Applicant	:	Liu Guo LIN)	PRELIMINARY AMENDMENT
Application No.	:	Unknown)	
		(Divsional of 09/663,692))	
Filed	:	December 21, 2001)	
For	:	STRUCTURE OF SEMICONDUCTOR ELECTRONIC DEVICE AND METHOD OF MANUFACTURING THE SAME)	26694
Attorney Docket	:	32014-177429)	PATENT AND TRADEMARK OFFICE

**REQUEST FOR
APPROVAL OF
DRAWING CHANGES**

Fig. 6

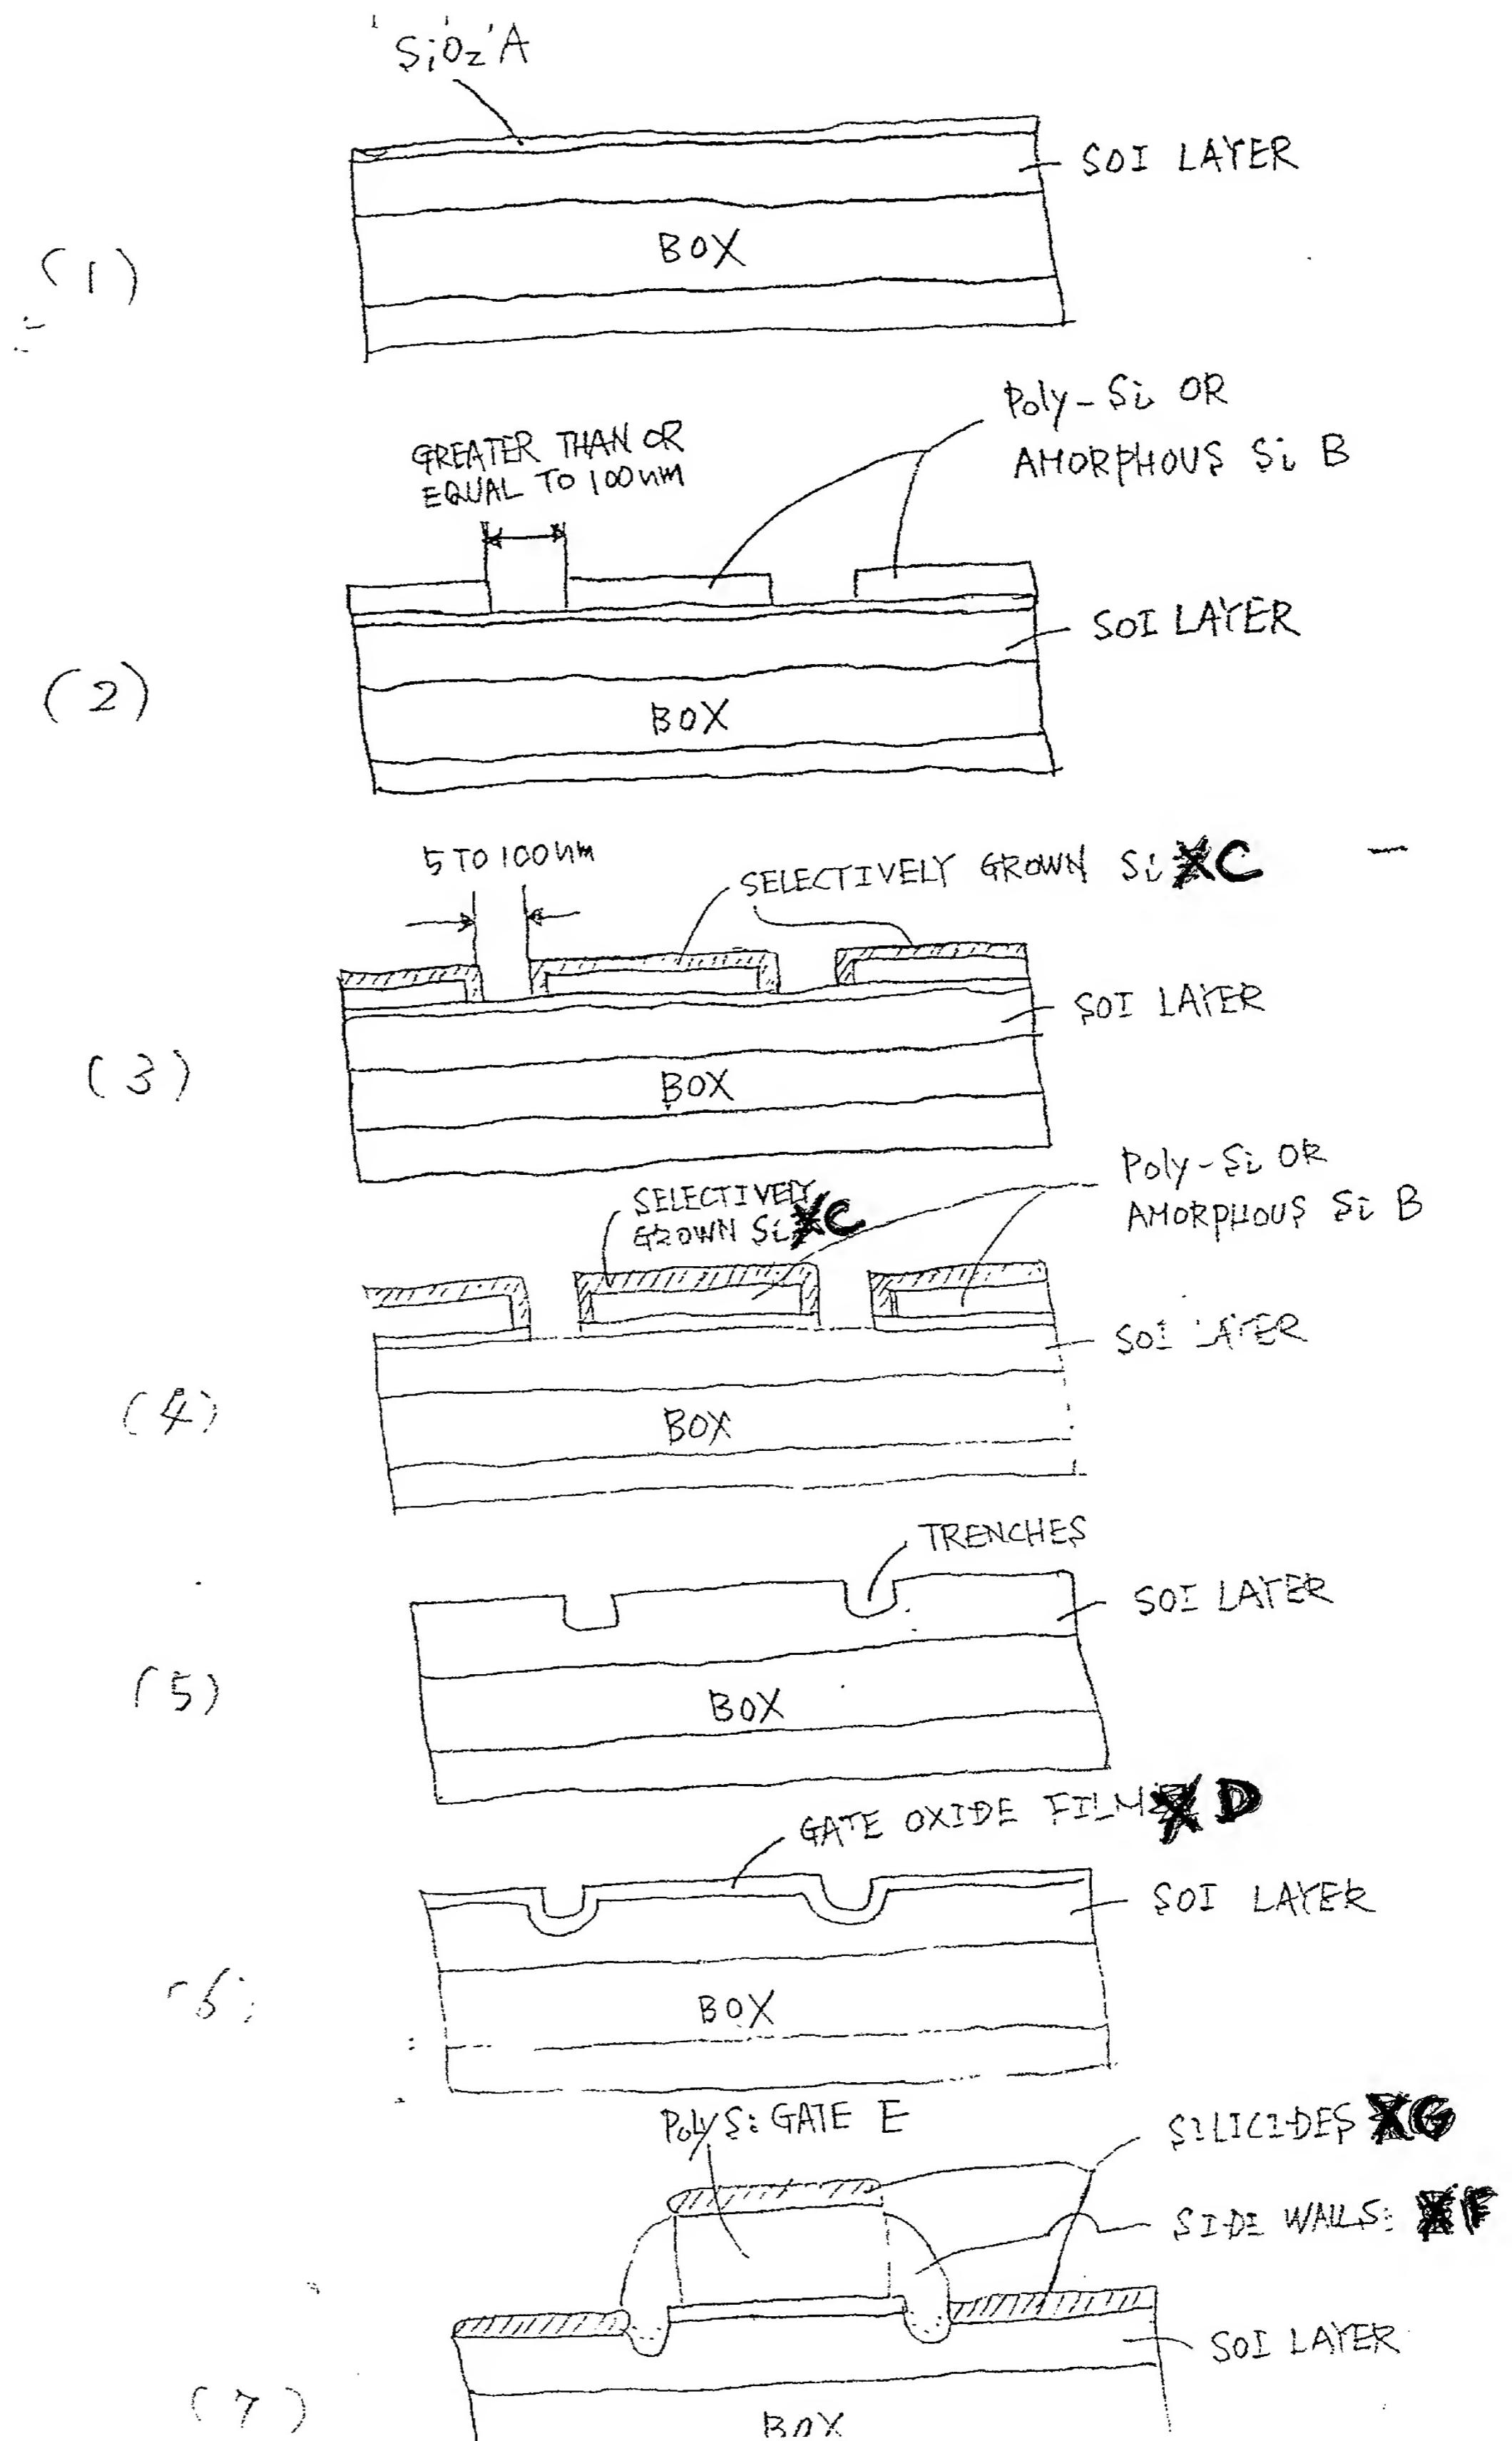
In the structure of the present invention as shown in Fig. 6(7), the degree of convexity of the oxide film below each side wall into [downward of] the SOI substrate can be controlled by varying the thickness of the silicides upon formation, with respect to each other [according to the thickness of the silicides upon formation of the silicides different in thickness from each other]. The silicides do not get under the side walls upon formation when the silicide films differ[ent] in thickness from each other. Further, silicide edges can be steeply controlled in the vertical direction along the sides of the side walls. The resultant device can achieve not only an increase in gate withstand voltage but also a decrease in gate leakage current.

Pursuant to the provisions in 37 C.F.R. § 1.121(d), Applicant requests approval of the drawing changes shown in red ink for Figures 6-8 on the attached three sheets.
